HISTORIC AND DESIGN REVIEW COMMISSION

HDRC CASE NO: 2022-292
ADDRESS: 516 E MULBERRY AVE
LEGAL DESCRIPTION: NCB 3090 BLK 6 LOT 9
ZONING: R-4 CD, H
CITY COUNCIL DIST.: 1
DISTRICT: Monte Vista Historic District
APPLICANT: Jose Calzada
OWNER: Rafael Saavedra Sada/ASTER DEVELOPMENTS LLC
TYPE OF WORK: New construction
APPLICATION RECEIVED: May 12, 2022
60-DAY REVIEW: Not applicable due to City Council Emergency Orders
CASE MANAGER: Rachel Rettaliata
REQUEST:

The applicant is requesting conceptual approval to construct two (2) 1-story, single-family structures at 516 E Mulberry.

Historic and Design Review Commission
Design Review Committee Report

7. Conceptual Site Plan

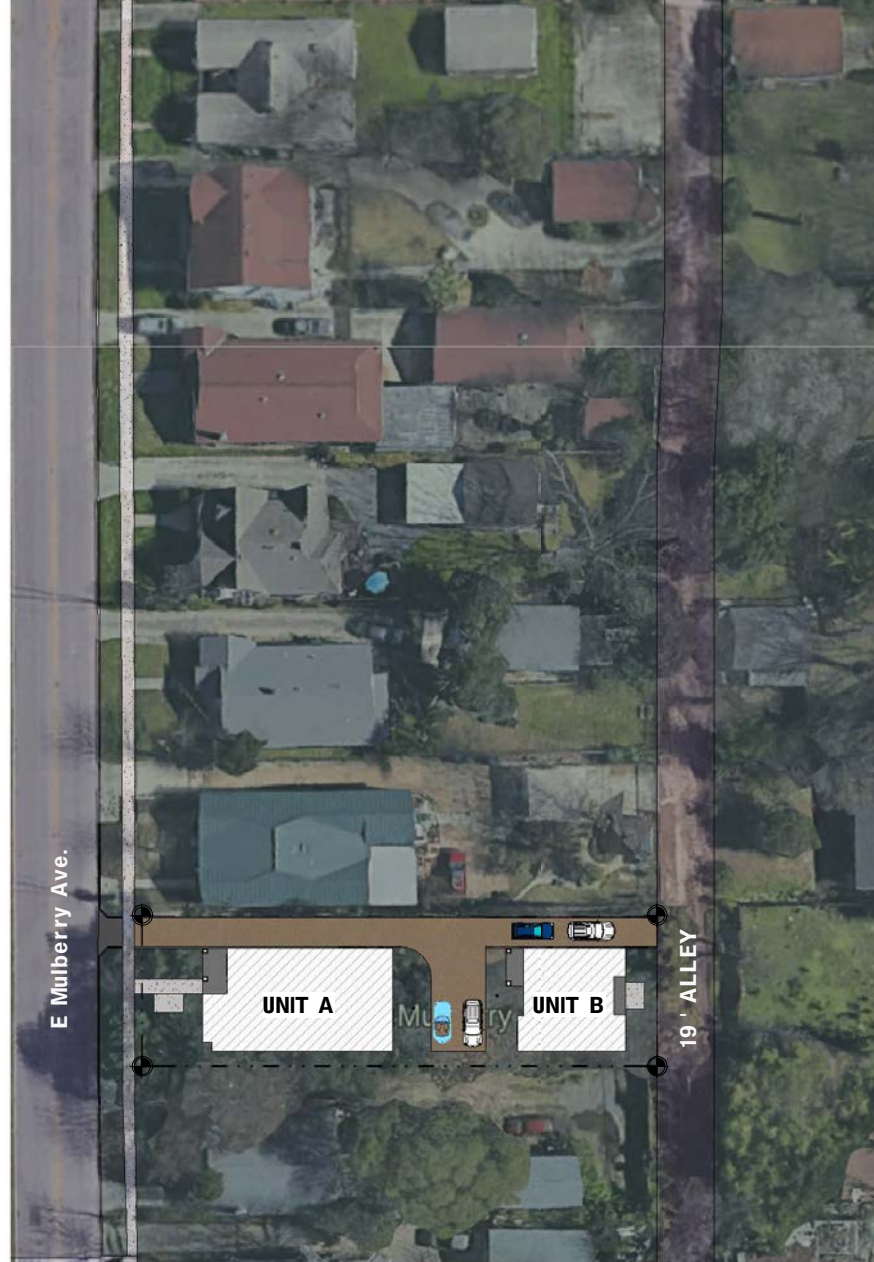
- p. DRIVEWAYS – Guideline 5.B.i for Site Elements notes that new driveways should be similar to those found historically within the district in regard to their materials, width, and design. Additionally, the Guidelines note that driveways should not exceed ten (10) feet in width. The applicant has proposed to install one decomposed granite driveway for the property that is 10 feet wide that spans the length of the property that terminates at the alley and features a central parking pad. Staff finds the proposal for a permeable driveway surface consistent with the Guidelines.

- r. SITE FURNISHINGS – The applicant has proposed to install a concrete pad next to the proposed front walkway that features four (4) benches in the front yard of Unit A and a concrete pad with two (2) benches at the rear of Unit B. Permanent site furnishings not commonly found on residential properties in historic districts. Staff finds the proposal inappropriate.

MS: You may want to introduce some green at the rear to denote a stopping point at the driveway. The rear house should also be subordinate to the main house, or the house in the front. Something to keep in mind as you develop this further.

Jeffrey Fetzter: The site plan seems appropriate, where the large house is on the street front and an accessory building in the back. I would revisit the height of the rear building and the accessory building has larger windows on the second floor, which makes it look more prominent. What is the width of the driveway?

JF: I would look at the seating area in the front and the width of the sidewalk to see how that relates to the rest of the neighborhood. You may want to explore another material for the seating area so that the sidewalk is prominent.

JF: Do you have a site plan showing the adjacent property setbacks? I would recommend including the dimensions of the surrounding setbacks.

LG: Is the driveway on the property line? I would recommend creating some space between the house and the driveway.

- ix. That the applicant modifies the proposed site furnishings so that the proposal is in keeping with site elements commonly found in the district based on finding r.

8. Heights

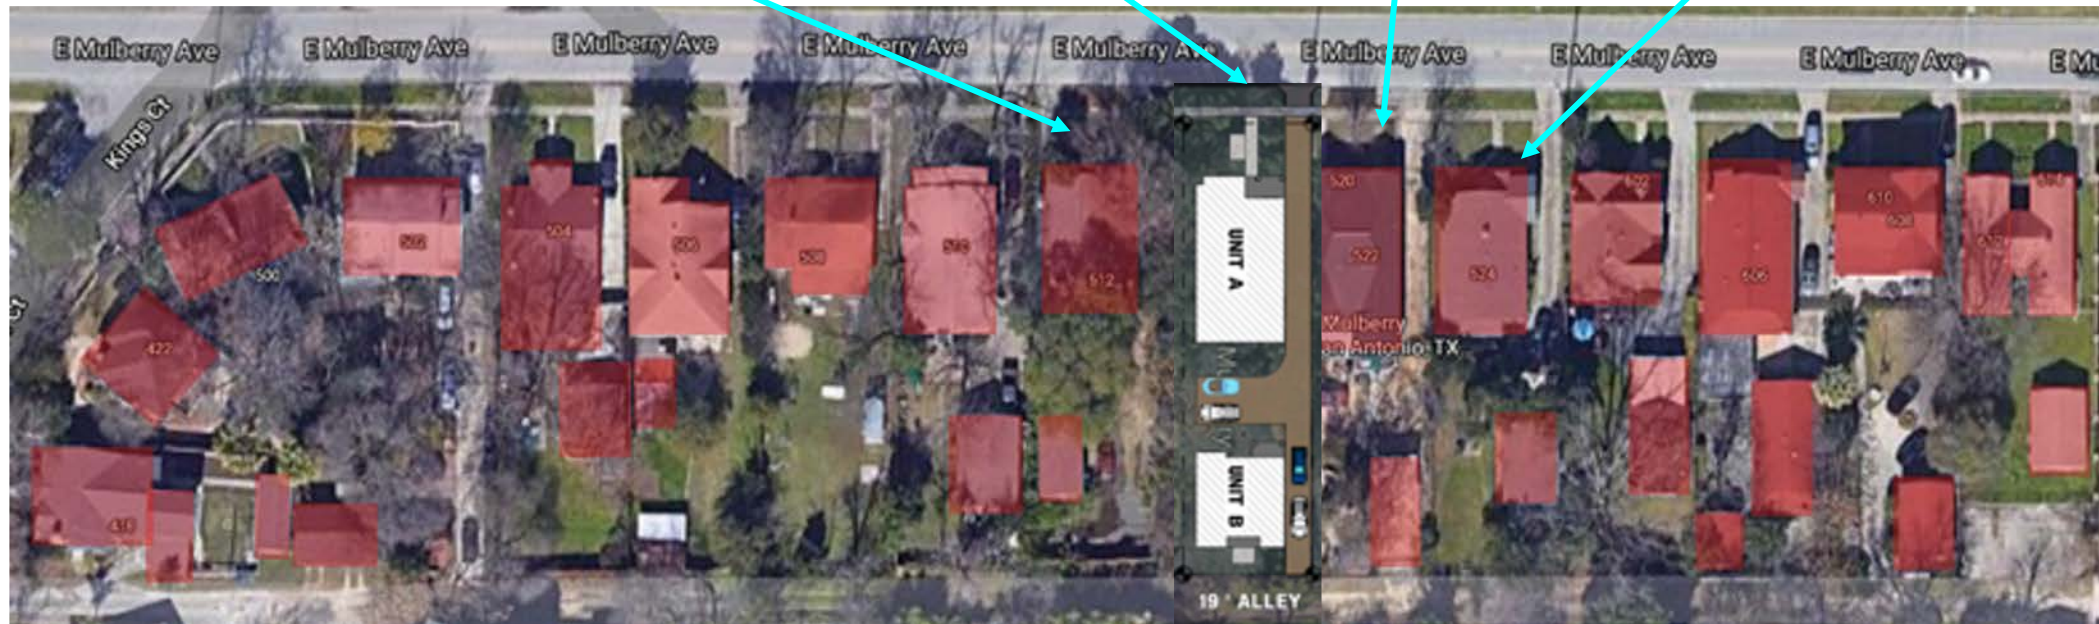
- f. SCALE & MASSING – According to Guideline 2.A.i for New Construction, new structures should feature a height and massing that is similar to historic structures in the vicinity. In residential districts, the height and scale of new construction should not exceed that of the majority of historic buildings by more than one story. The adjacent blocks of E Mulberry feature 1-story and 2-story structures. Guideline 2.A.ii for New Construction states that applicants should utilize step-downs in building height, wall-plane offsets, and other variations in building massing to provide a visual transition when the height of new construction exceeds that of adjacent historic buildings by more than one-half story. The applicant has provided height information and the proposed height of Unit A is 24.6 feet. Adjacent structures range from 20 feet in height to 30 feet in height. At this time, the applicant has not provided the total proposed height for Unit B. Staff finds that the applicant should provide total height information for Unit B and that the height of Unit B should not exceed that of the primary structure, Unit A.

- i. That the applicant provides total height information for Unit B showing that the structure does not exceed the height of the primary structure (Unit A) based on finding f.
